RE: "Maple Hill" Definitive Plan

Off-site Improvement Summary

BETA Group, Inc. continues to provide engineering peer review services for the proposed Definitive Plan application entitled "Maple Hill" located in Franklin, Massachusetts. This letter is provided to update findings, comments and recommendations.

Index & Phasing
Plan

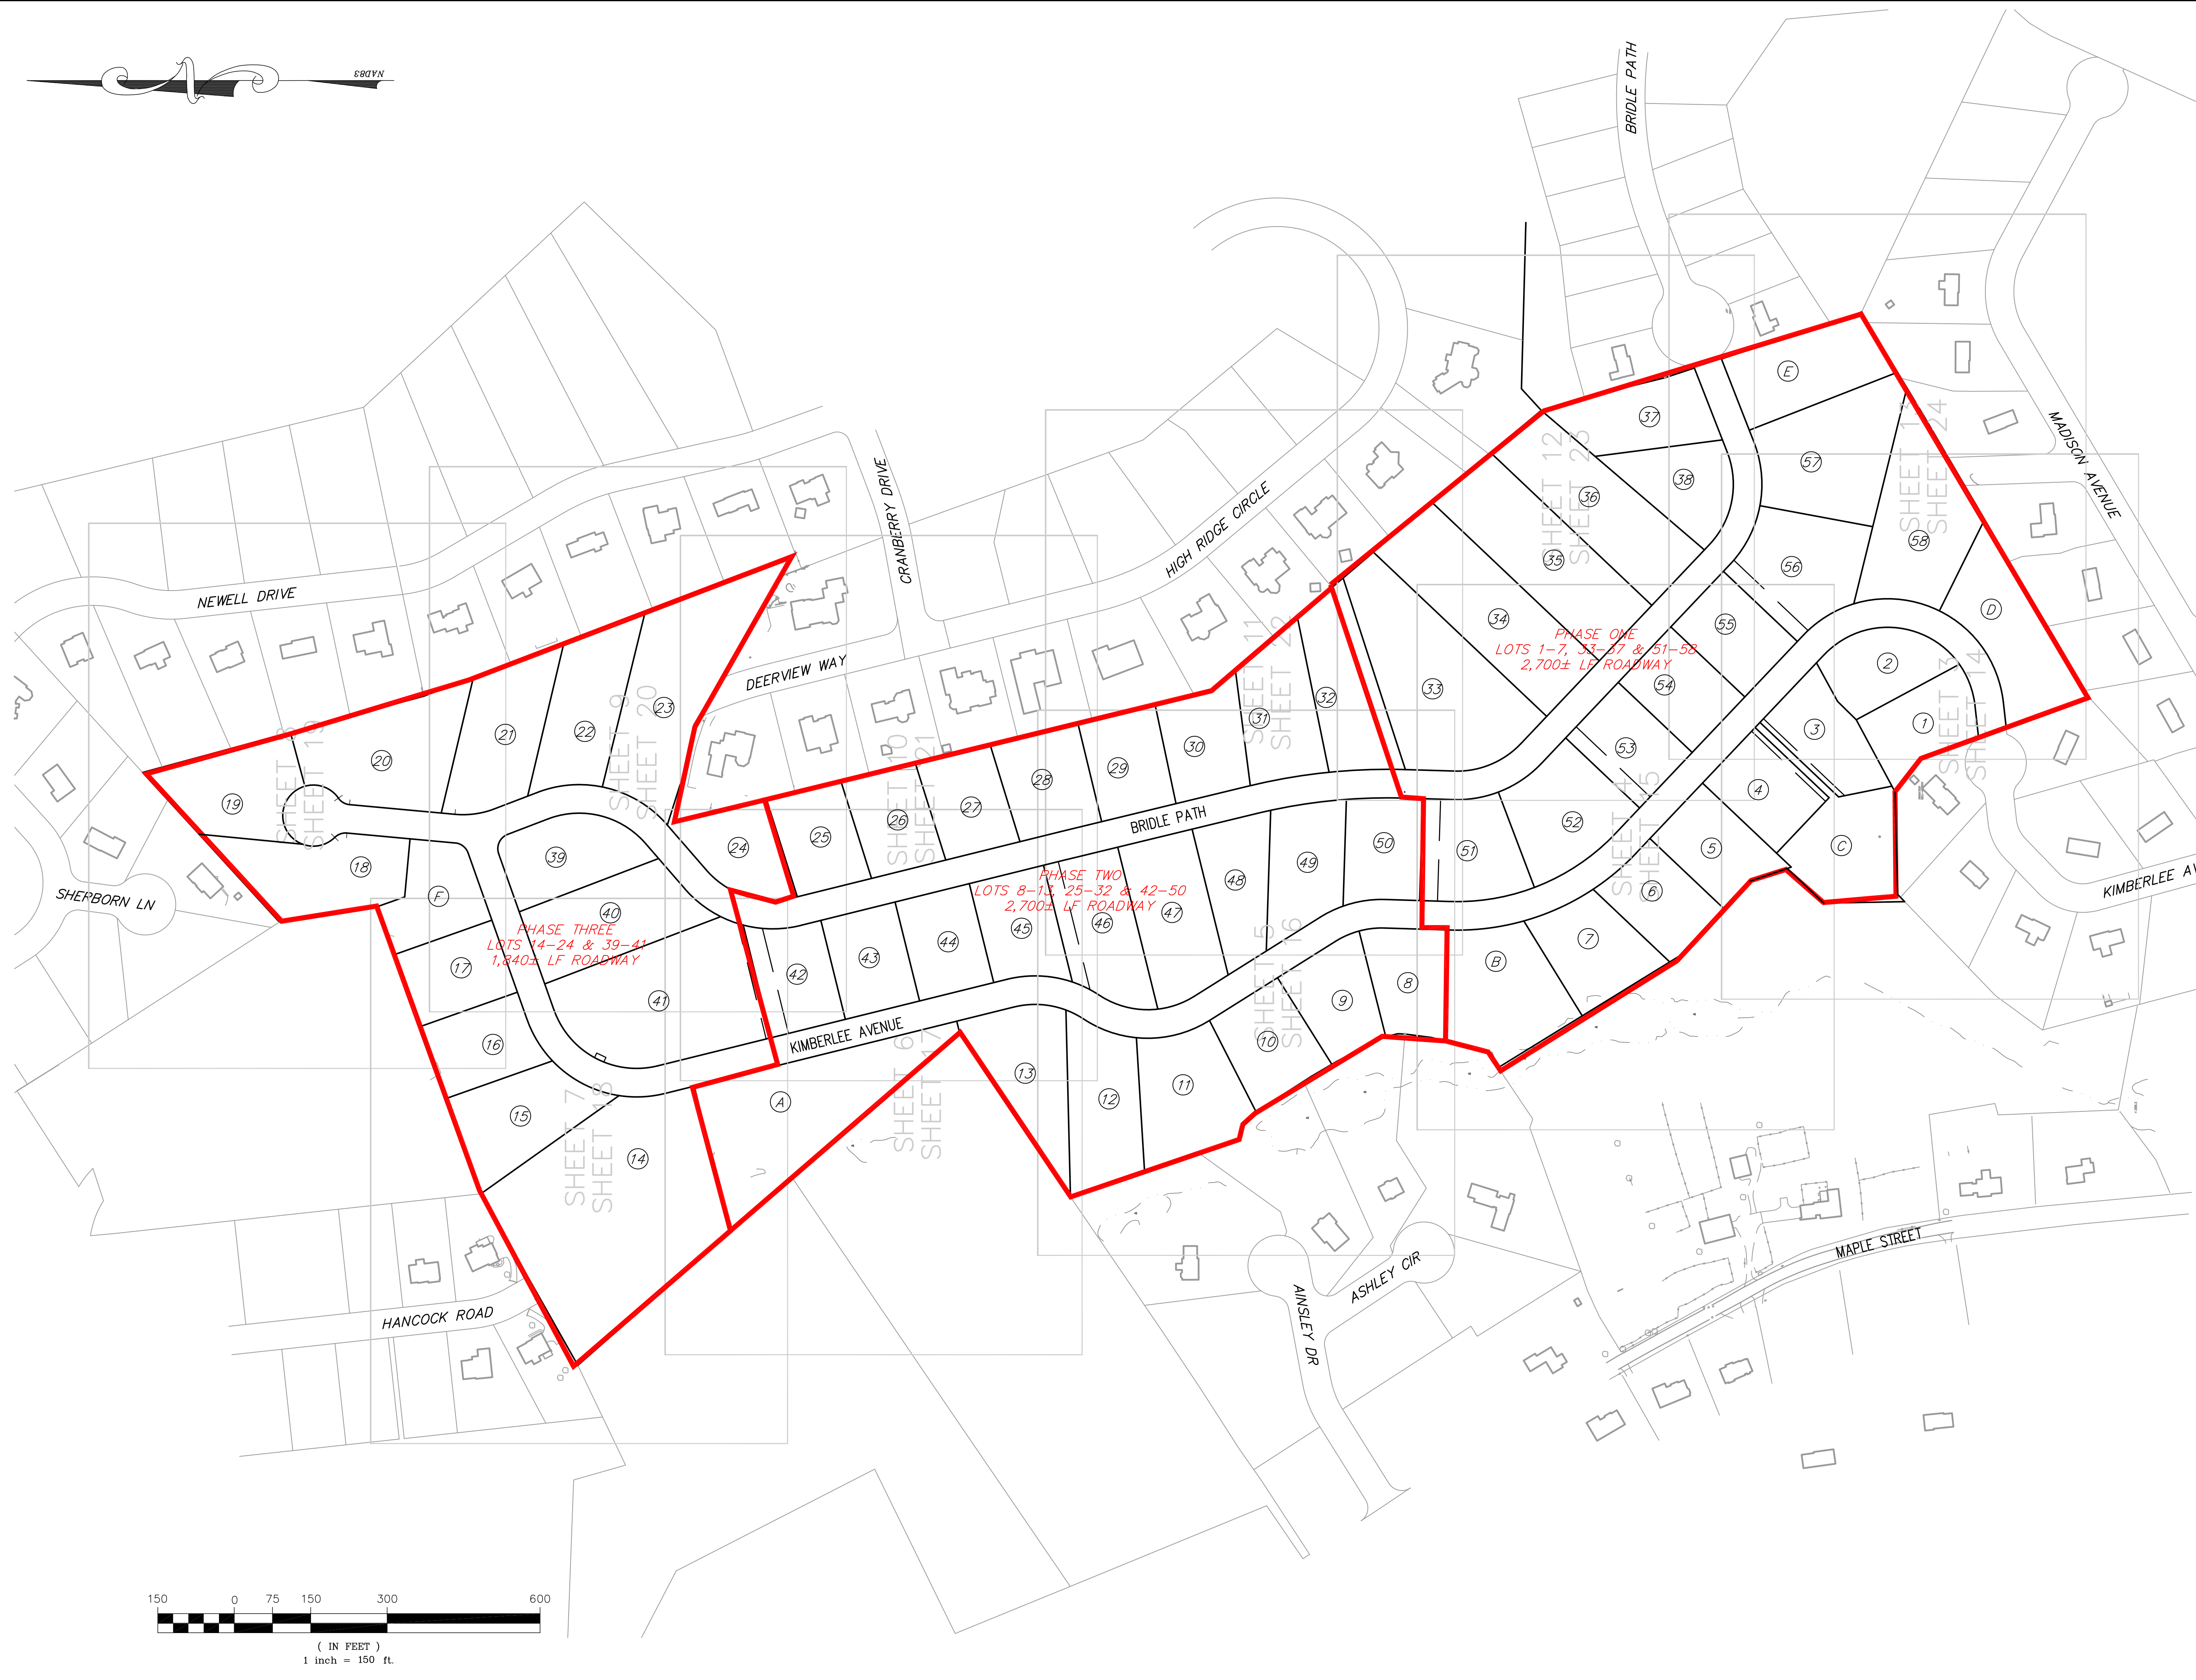
1. **Maple Street Sight Distance Improvements** – Work that is shown on the plan entitled “Maple Street Stopping Sight Distance Study Plan” by Vanasse & Associates, Inc. dated 9/16/2020. The work will be completed prior to the issuance of any building permits for Phase 2 of the Project. Said phasing is as shown on Sheet 2 of the Maple Hill definitive plan.

SW30. Depict the limits of each construction phase, as shown on the Index and Phasing Plan, on the SWPPP. *BCG: Modified as requested (Sheet 39). **BETA2: Information provided – issue resolved.***
